***Half Moon Bay/Pillar Point
Ground-Water Basin Report
Phase II***

***Supplemental Data
June 1992***

**SUBJECT: SUPPLEMENTAL DATA FOR THE HALF MOON BAY/
PILLAR POINT GROUND-WATER BASIN REPORT, PHASE II**

RE: Half Moon Bay Airport/Pillar Point Marsh
 Ground-Water Basin Report Phase II

SURFICIAL GEOLOGIC MAP

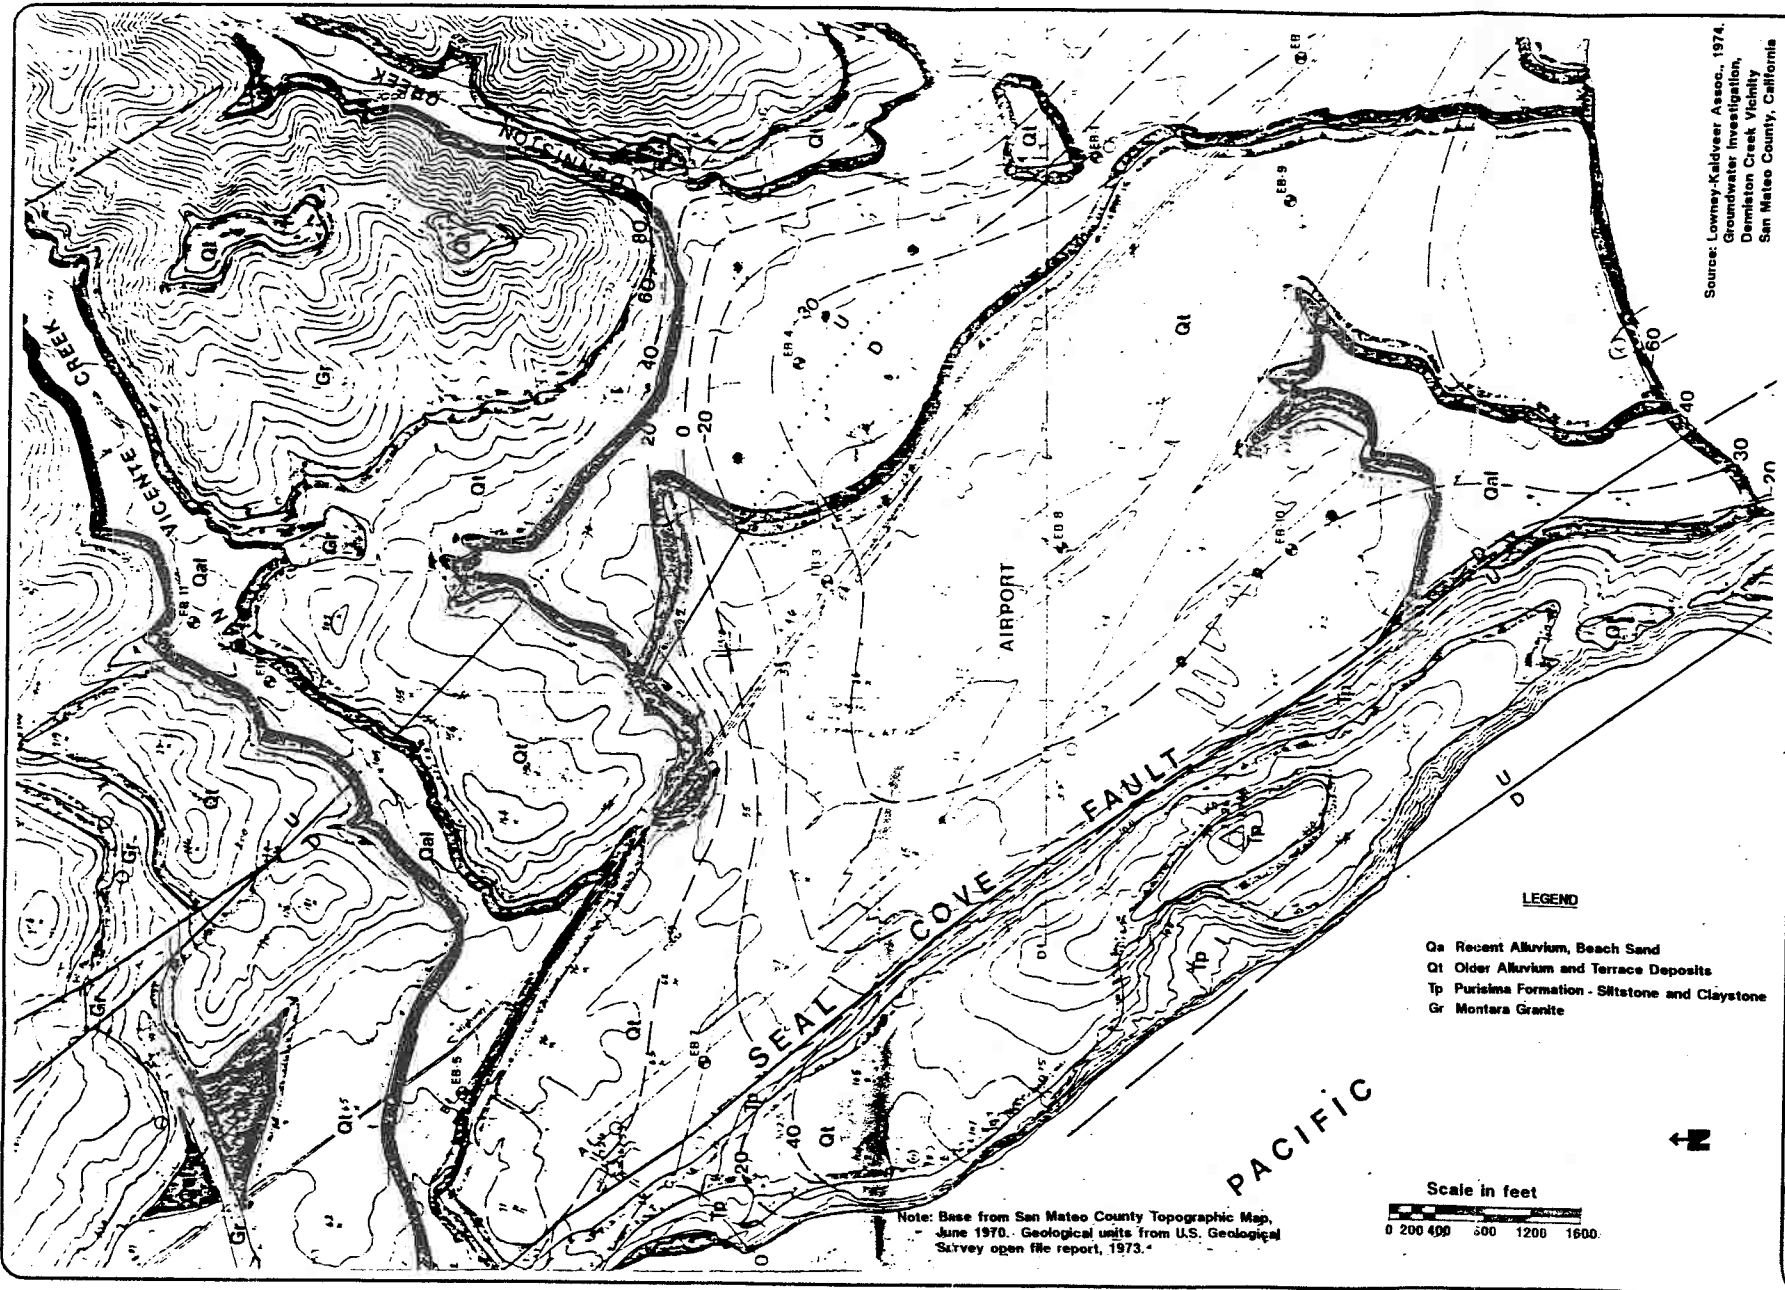
CC4b. Include a geologic map showing physical boundaries of the basin.

CC4b. [LSCE] - The study area, including descriptions of physical boundaries, was described on page 6 of the Phase II report. Also on page 6, it was noted that a previous study of the basin **Groundwater Investigation, Denniston Creek Vicinity** by Lowney-Kaldveer Associates (1974) presents a good description of geologic conditions within the basin. The study was primarily a geologic exploration report. For purposes of responding to the Commission's comment, a portion of the geologic map contained in the Lowney-Kaldveer report is attached. For purposes of the Half-Moon Bay/Pillar Point Marsh study, hydrogeologic conditions were discussed in Section IV of the report.

FIGURE
 CONTOURS OF EQUAL GROUND-WATER ELEVATIONS, APRIL 1992
 HALF MOON BAY AIRPORT/PILLAR POINT MARSH

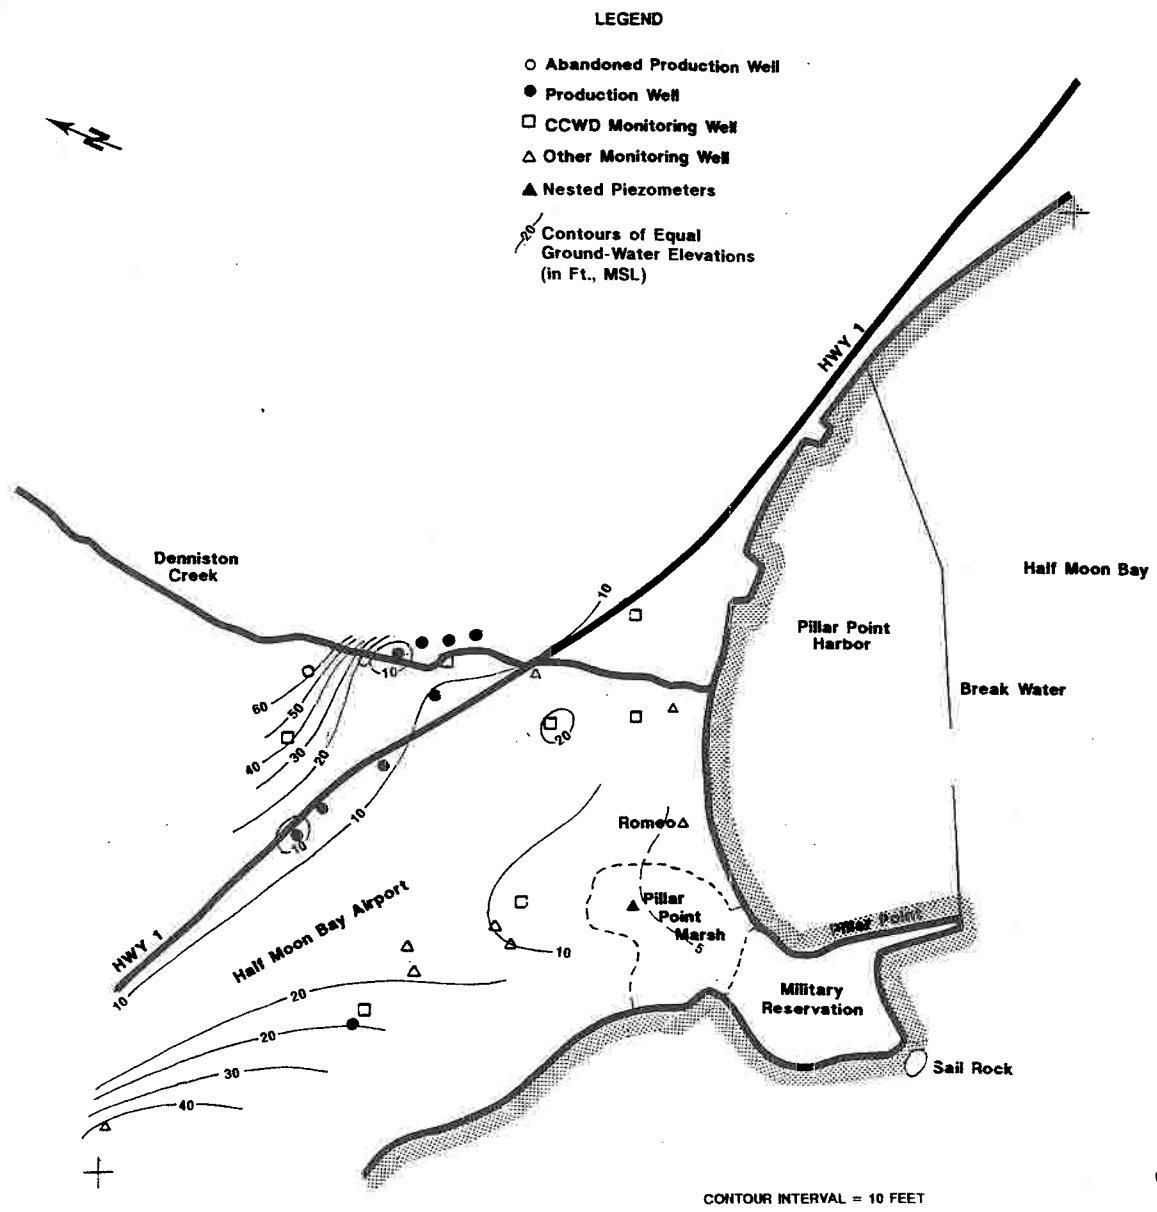
CC9. Discuss ground-water hydrographs included in Appendix 1 relative to the "overall downward trend in ground-water elevations".

To further illustrate ground-water conditions in the basin following more normal periods of precipitation, contours of equal ground-water elevation were prepared for spring 1992 (measurements obtained April 3, 1992). The contours continue to show that ground-water elevations remain above sea level along the Half Moon Bay coastline. Another figure has also been prepared to illustrate the changes in ground-water elevations from December 1990 to April 1992. As shown in that figure, ground-water elevations have increased significantly along the northern portion of Denniston Creek and the northern part of the basin. Between December 1990 and April 1992, ground-water elevations rose by about 10 to 25 feet in those areas. Along the southwest side of the basin and toward the marsh, ground-water elevations generally increased by more than five feet during that period. It is significant to note that wells MW3 and MW4, which are generally located further from pumping areas than other monitoring wells, in the network, exhibited ground-water elevations in April 1992 which equal or exceed those observed in May 1987 at the beginning of the study.
